August 20, 2020

RE: Sunnyside Refuse and Slurry C/007/0035
Task ID #6149 Midterm Permit Review

Title: Respond to comments from Midterm Review (Task #6149)

Sunnyside Cogeneration Associates
SOIL IDENTIFICATION MAP

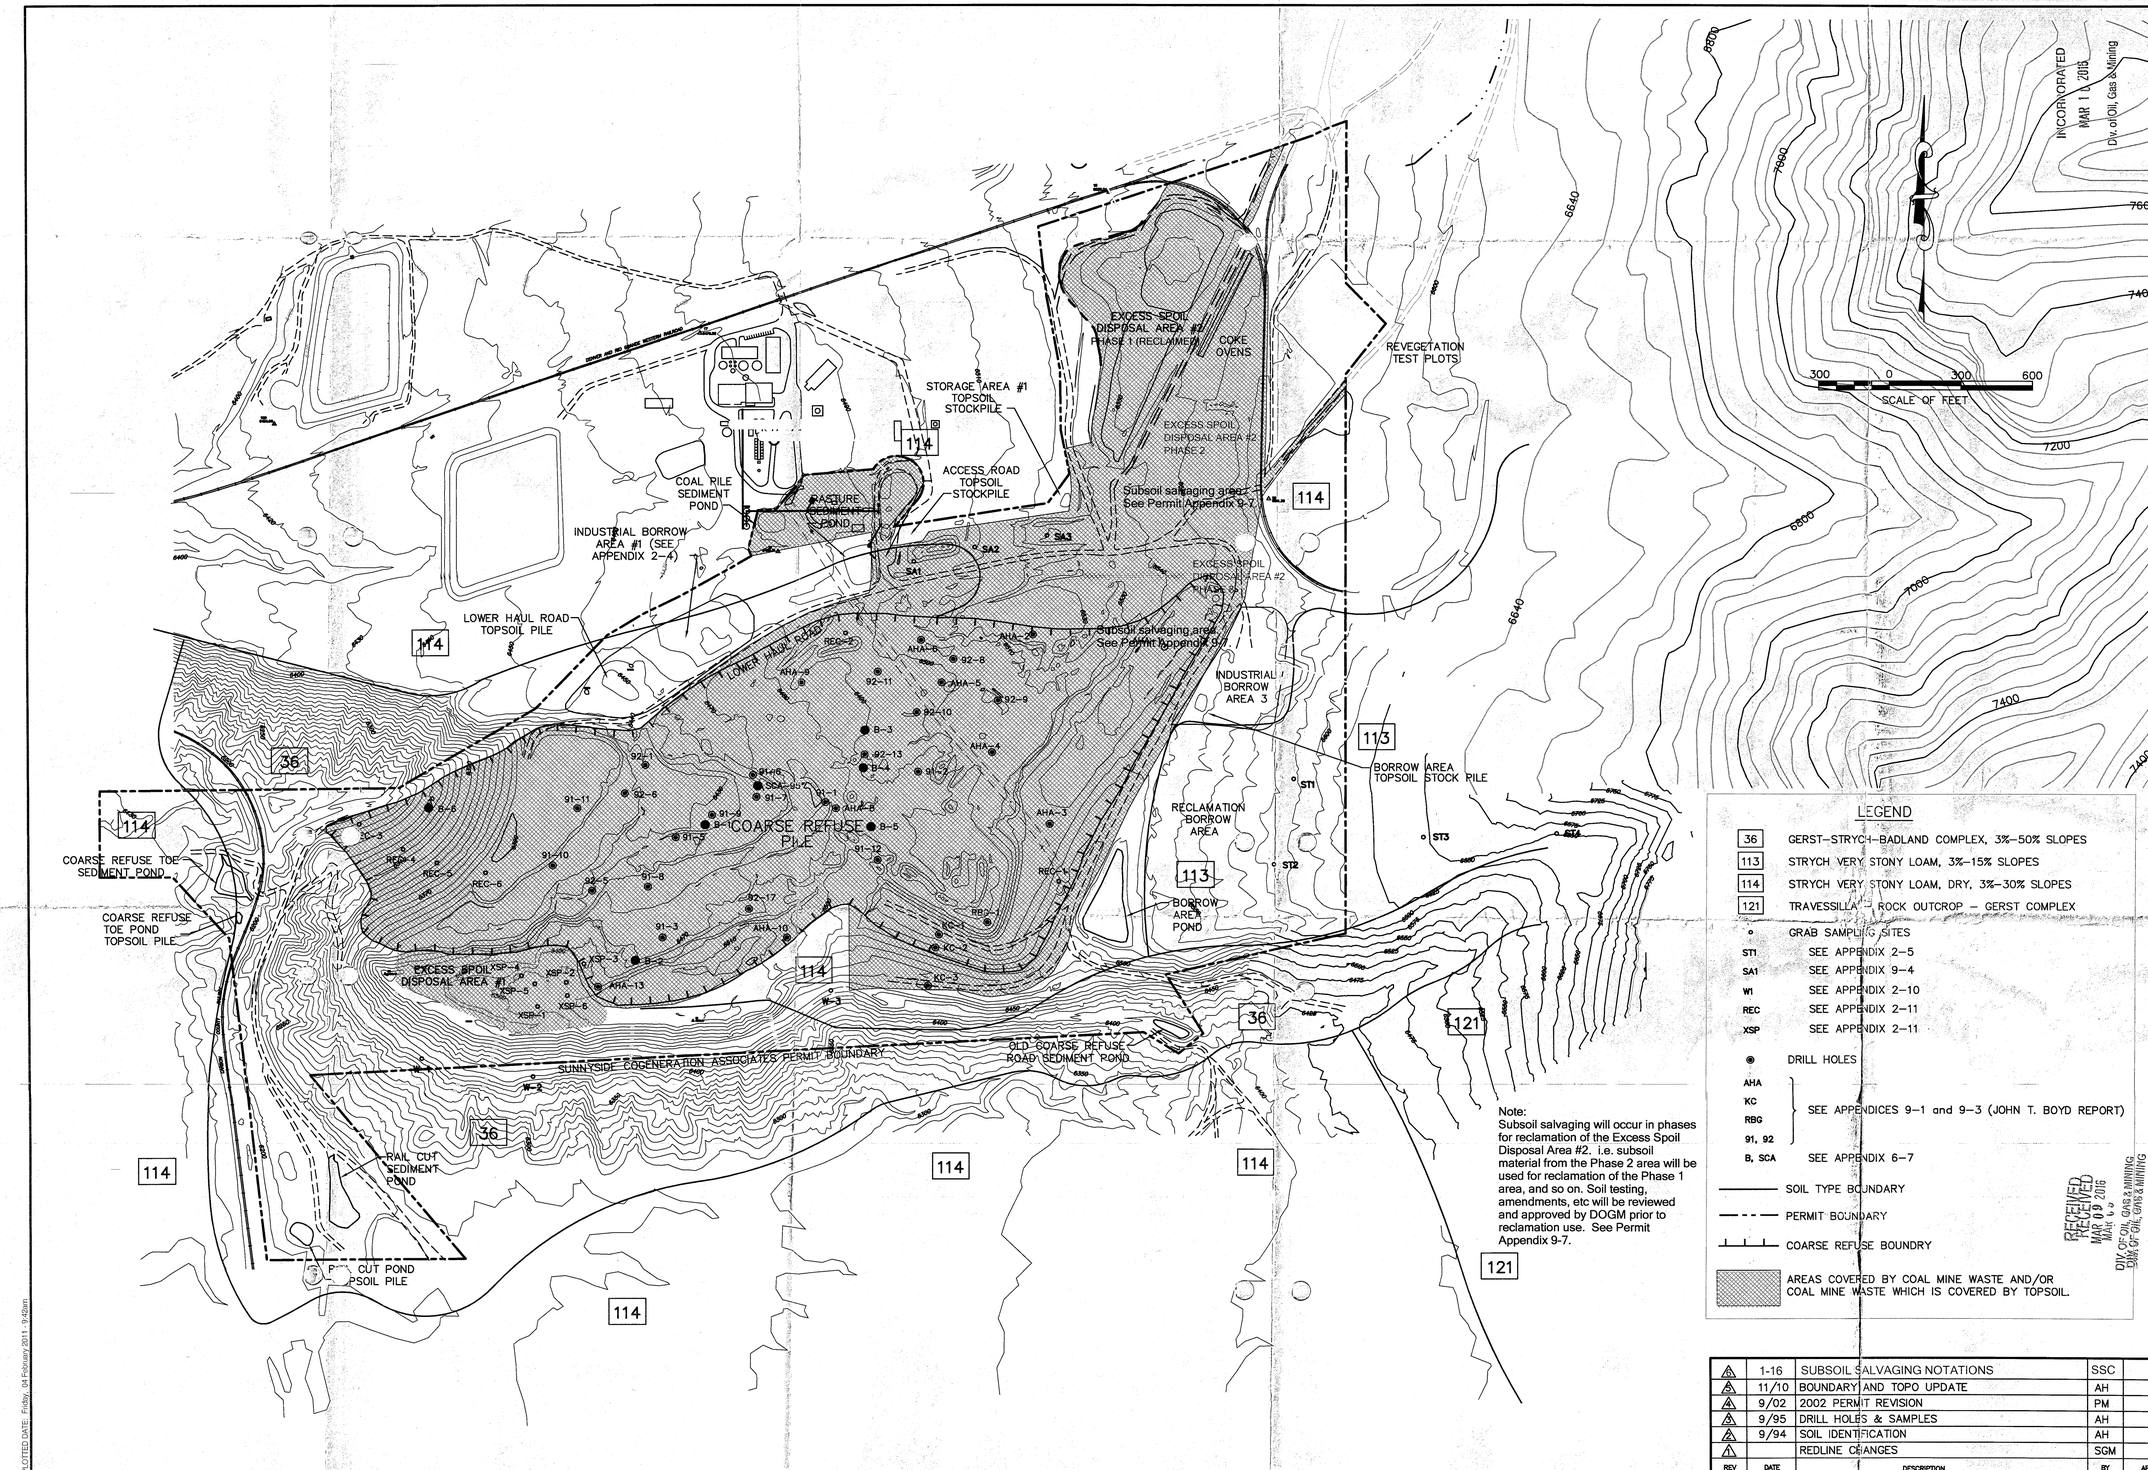
R645-301-122, Please provide a copy of the map in Appendix B of Appendix 2-9 to complete the Division's copy of the Mining and Reclamation Plan.

SCA has included a copy of the drawing Plate 2-1, which was originally incorporated, by the Division, on March 10, 2015.

Sunnyside Cogeneration Asso
HYDROLOGIC INDEX MAP

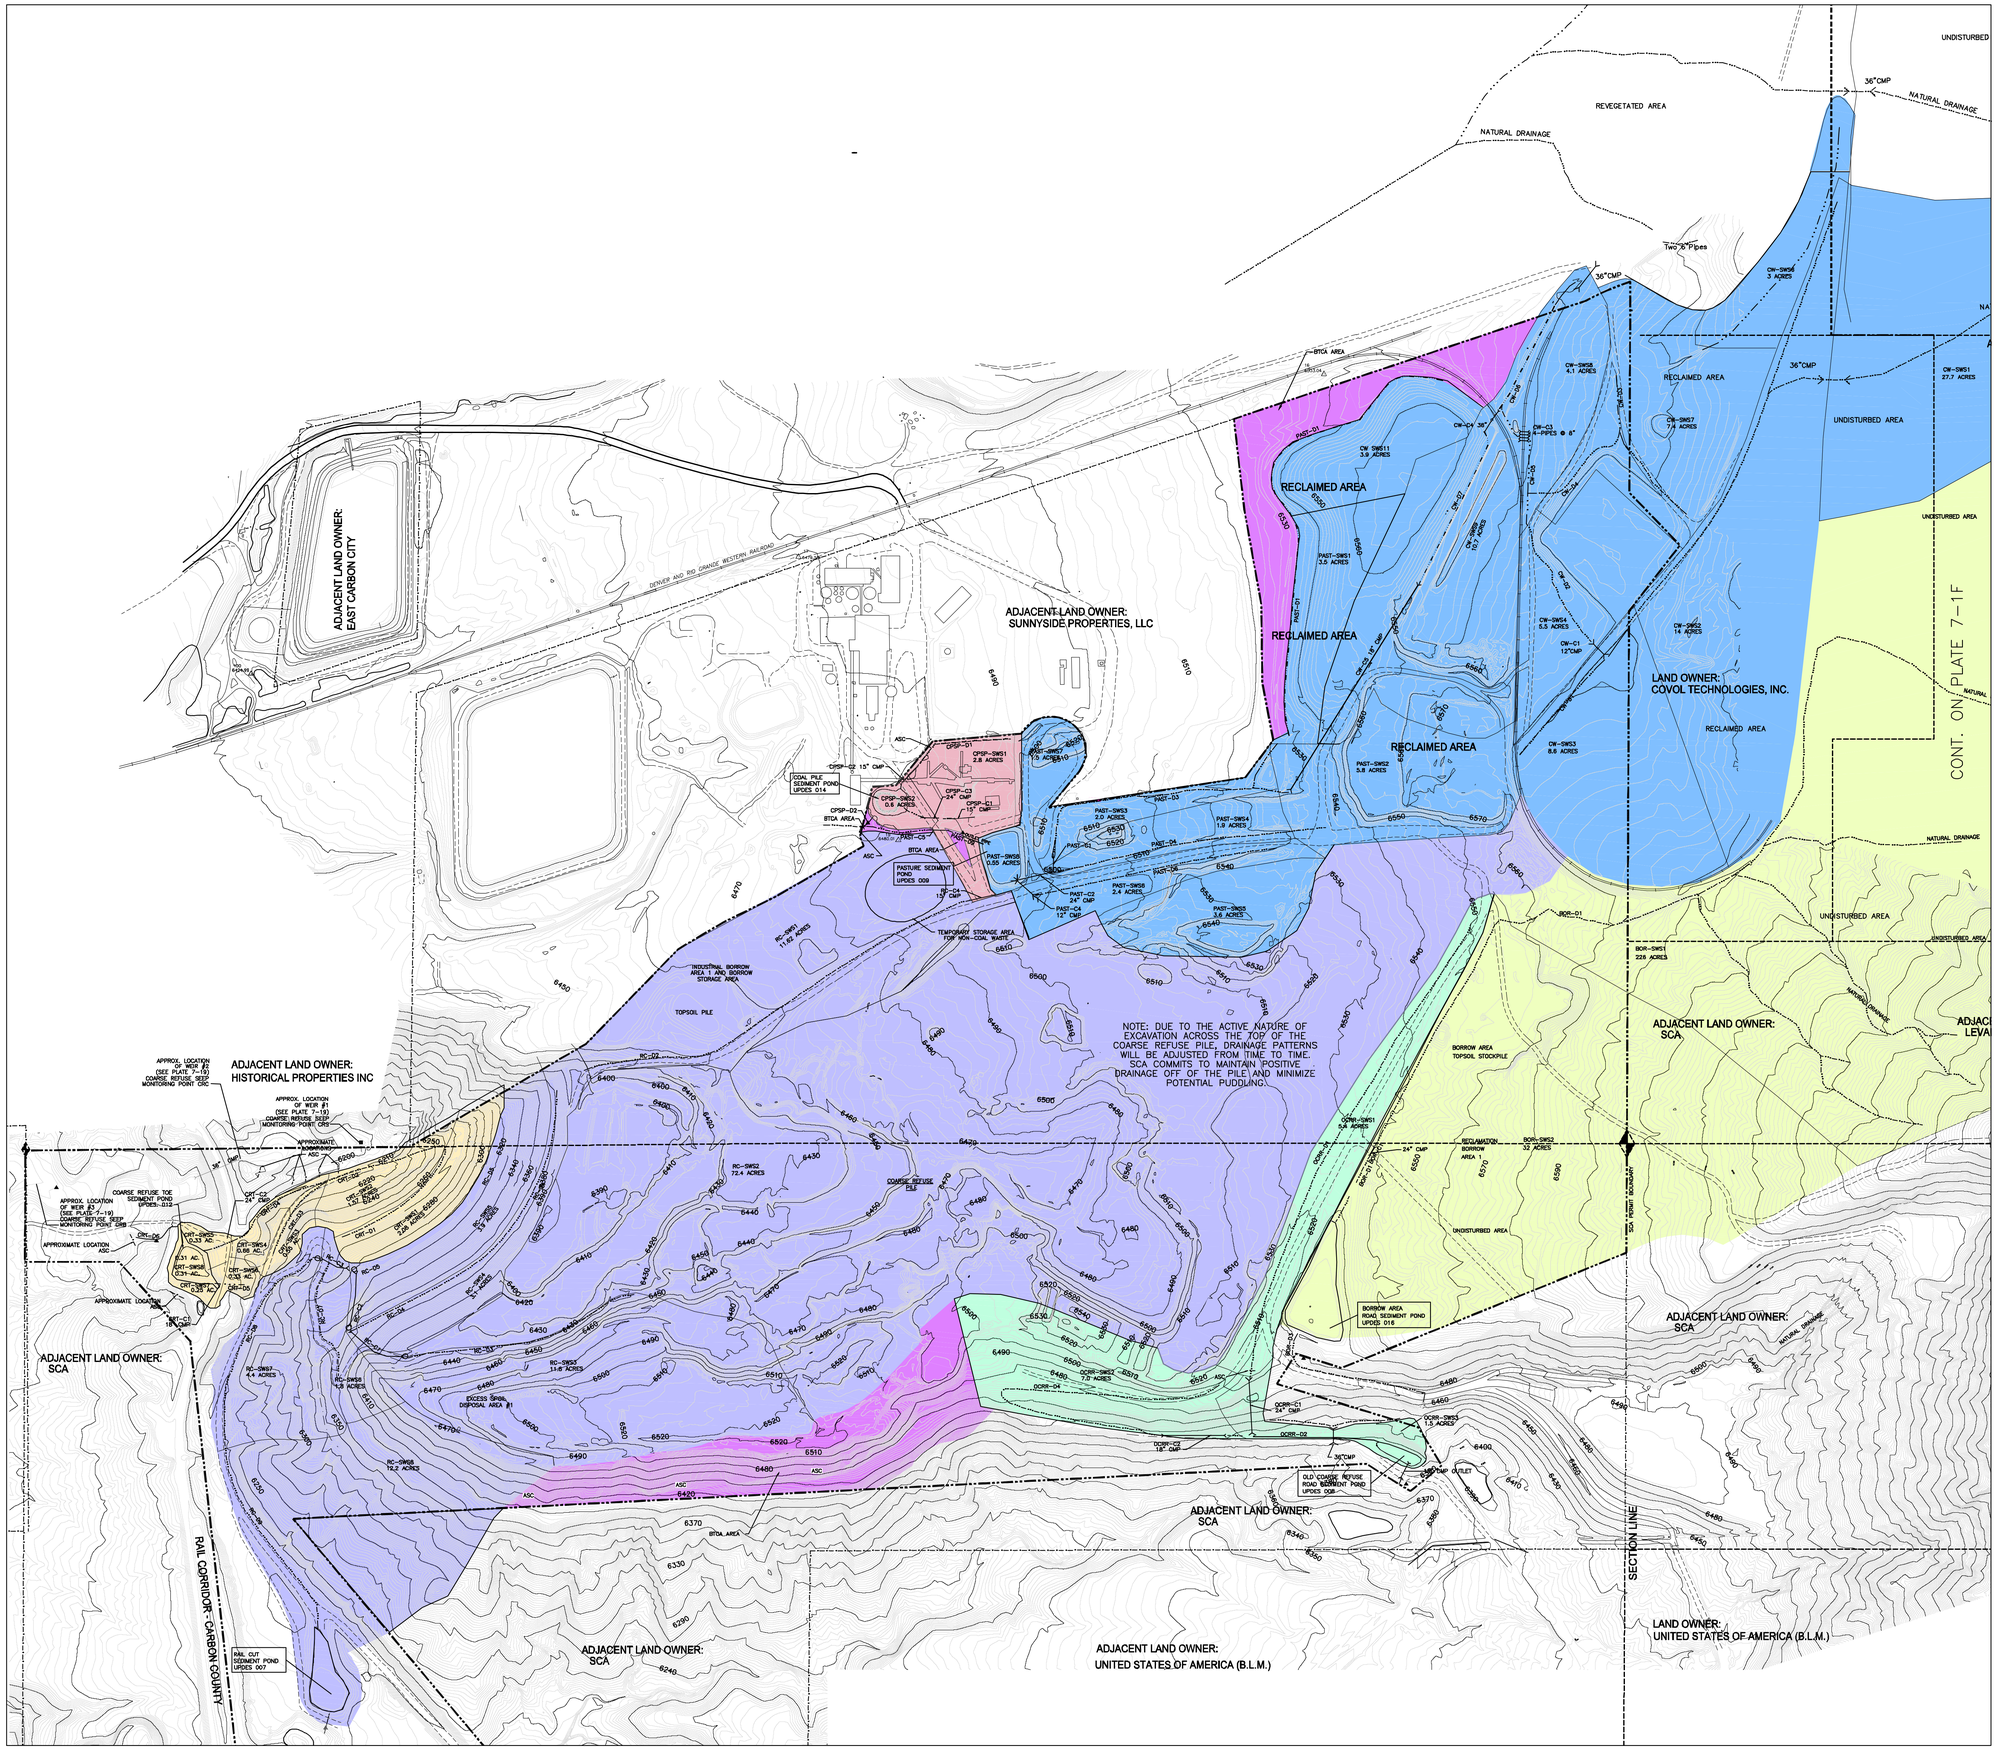
R645-301-733, The Permittee must re-evaluate the pond drawing for the Pasture Pond. Specifically, the existence of the 18" culvert and rip-rap inlet ditch as shown on Plate 7-9. The Permittee must also update the table of contents to remove Plate 7-1G and include an updated description of Plate 7-1F to include both the Borrow and Pasture Pond Upper Drainage.

SCA has included an updated red-lined table of contents, included an updated pond drawing Plate 7-9, included an updated drawing Plate 7-1 and included updated red-lined text where it was needed.
